# **Task Force on Electro-Magnetic Compatibility (TF EMC)**

**Status report to GRE-80**  
**Thursday, 25<sup>th</sup> of October 2018**

# TF EMC Status Report – UN R10.06 Development

Clarification of failure criteria for vehicle in charging mode immunity tests (annexes 6, 15 and 16)

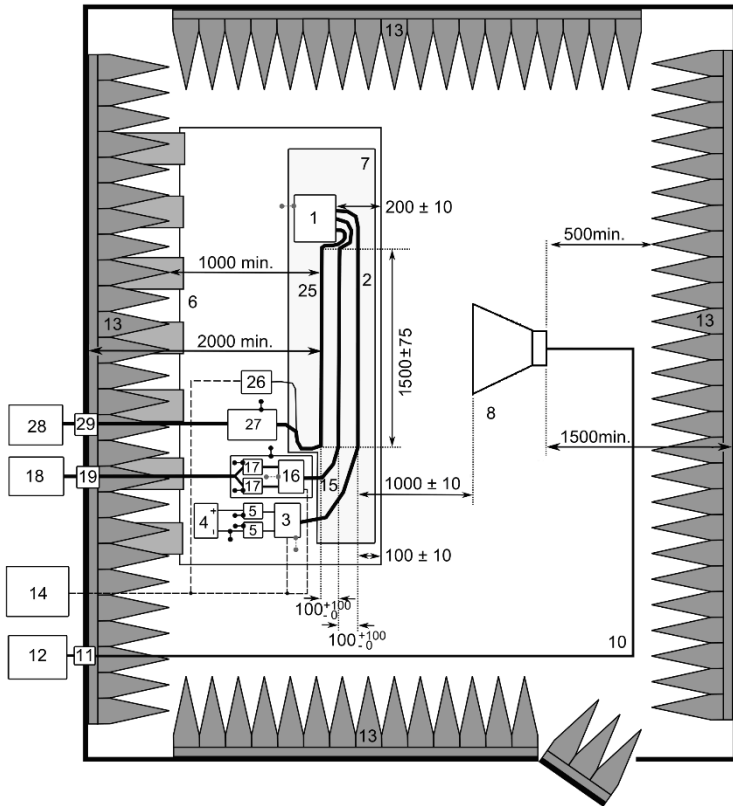
“1” <i>"REESS charging mode" vehicle test conditions</i>	<i>Failure criteria</i>
<p>The REESS shall be in charging mode. The REESS State of charge (SOC) shall be kept between 20 per cent and 80 per cent of the maximum SOC during the whole frequency range measurement (this may lead to split the measurement in different sub-bands with the need to discharge the vehicle's traction battery before starting the next sub-bands). If the current consumption can be adjusted, then the current shall be set to at least 20 per cent of its nominal value.</p> <p>In case of multiple batteries the average state of charge must be considered.</p>	<p>Vehicle sets in motion.</p> <p><del>Electric parking brake warning indicator OFF</del></p> <p><b>Unexpected release of the parking brake.</b></p> <p><b>Loss of Parking position for automatic transmission.</b></p>

Correction of figure x at Annex 9 – Appendix 3 (part 2/2)

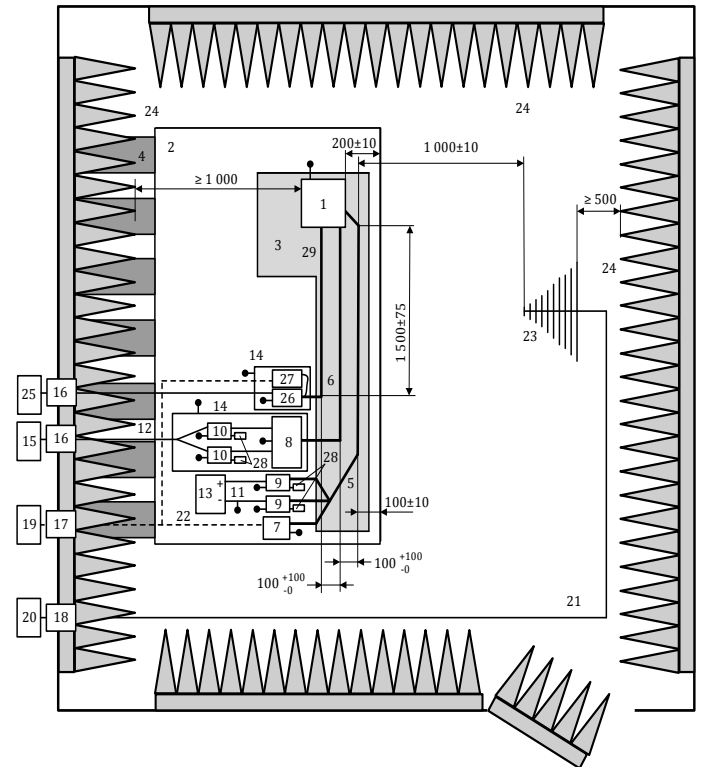
Top view (Vertical polarization)
